CERTIFICATE OF APPROPRIATENESS

Property: 504 Avondale St, lot 2, tract 3A, block 6, Montrose Subdivision. The property includes a historic 3,124 square foot two-story residence situated and detached garage on a 7,800 square foot (60' x 130') interior lot.

Proposal: Alteration – Replace 22 wood 1-over-1 windows on both side elevations of the structure with wood 1-over-1 windows to fit within existing openings.

Recommendation: Denial – does not satisfy criteria 1, 4, 5, 9

APPLICANT SUBMITTAL MATERIALS

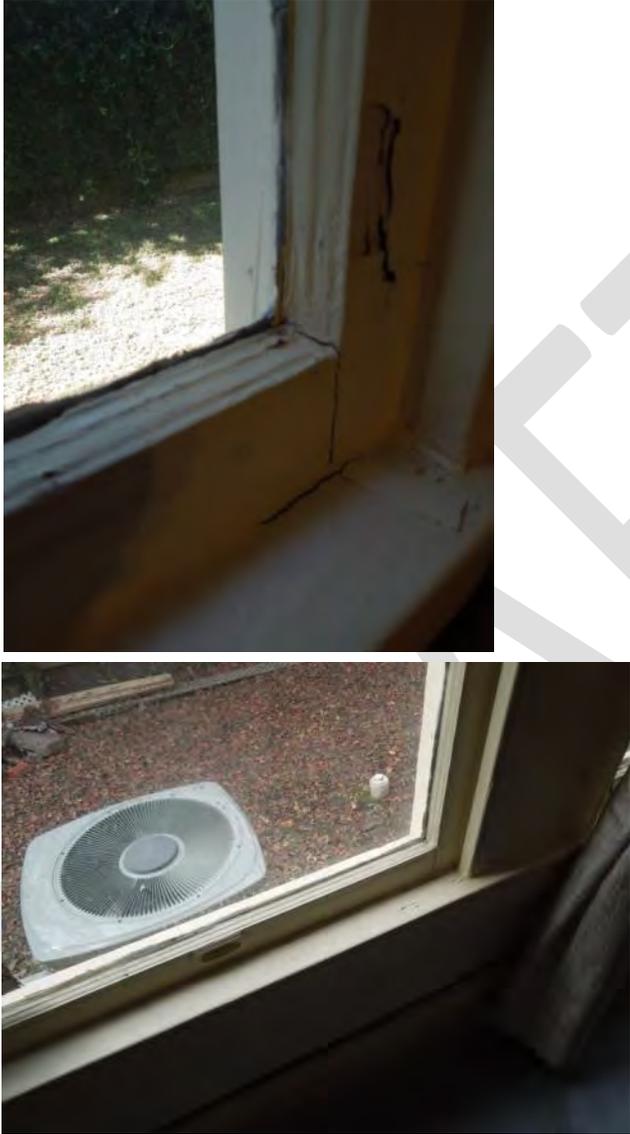
<i>The original wood windows are a distinguishing feature of the property and should be retained. Staff confirmed some damage of the original windows but believe they are not beyond reasonable repair.</i> |

<i>The original wood windows are a distinguishing feature of the property and should be retained. Staff confirmed some damage of the original windows but believe they are not beyond reasonable repair.</i> |

STAFF INSPECTION RESULTS

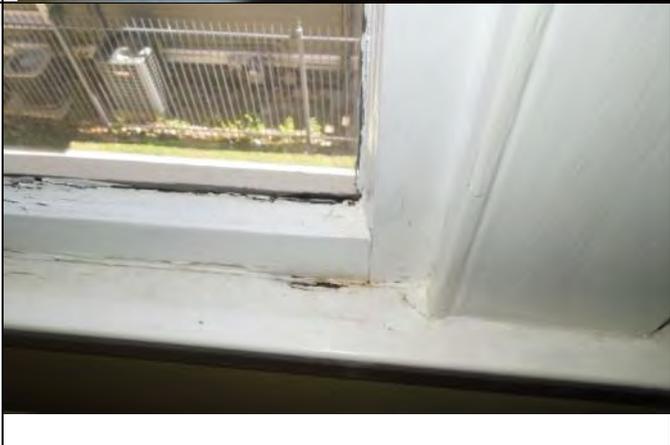
WINDOW	STAFF PHOTO	STAFF FINDINGS	RECOMMENDATION
E1a		Cracked paint; Painted shut	Repair

E1b		Painted shut; flaking paint; meeting rail slipping slightly	Repair
E2	Glass Block

<p>E3a</p>		<p>Painted shut; loose glass; bowing bottom rail of upper sash</p>	<p>Repair, re-glaze, possibly replace bottom rail of upper sash</p>
<p>E3b</p>		<p>Painted shut; flaking paint</p>	<p>Repair</p>
<p>E6a</p>		<p>Painted shut; flaking paint</p>	<p>Repair</p>

E6b		Painted shut; flaking paint; lower sash bottom rail slightly out on left side	Repair and reconnect bottom rail
E7a		Painted shut; flaking paint	Repair

E7b		Painted shut; flaking paint	Repair
E7c		Painted shut; flaking paint	Repair

E8		Painted shut; meeting rail slightly dislocated but solid	Repair
E9a		Rotted bottom rail of lower sash; painted shut	Replace bottom rail of lower sash

E9b		Painted shut; flaking paint	Repair
E10		Painted shut; flaking paint; tiny softness on bottom rail of lower sash	Repair, possibly wood filler
E11	Fixed		
E12	Fixed

E13a		Painted shut	Repair
------	--	--------------	--------

E13b		Painted shut; loose glass	Repair and re-glaze
E16a		Painted shut; flaking paint; meeting rail slipping slightly but solid	Repair, reattach bottom rail of upper sash

E16b		Painted shut; glass slipping	Repair and re-glaze
E17a		Painted shut; no cord; bottom rail of lower sash tiny bit soft	Replace cords, possibly wood filler for rails or replacement rail

E17b		Painted shut	Repair
E18		Partially rotten sill; Painted shut; upper sash bottom rail bowing	Possibly replace bottom rail of upper sash, repair sill

<p>E19a</p>		<p>Painted shut; loose glass, soft sill; rotting bottom rail of upper and lower sashes</p>	<p>Re-glaze, possibly replace bottom rails of upper and lower sashes</p>
<p>E19b</p>		<p>Painted shut; upper sash bottom rail slipping, slightly soft; bottom rail lower sash soft on edges; loose glass</p>	<p>Re-glaze, possibly replace bottom rail of lower sash, reattach upper sash bottom rail</p>
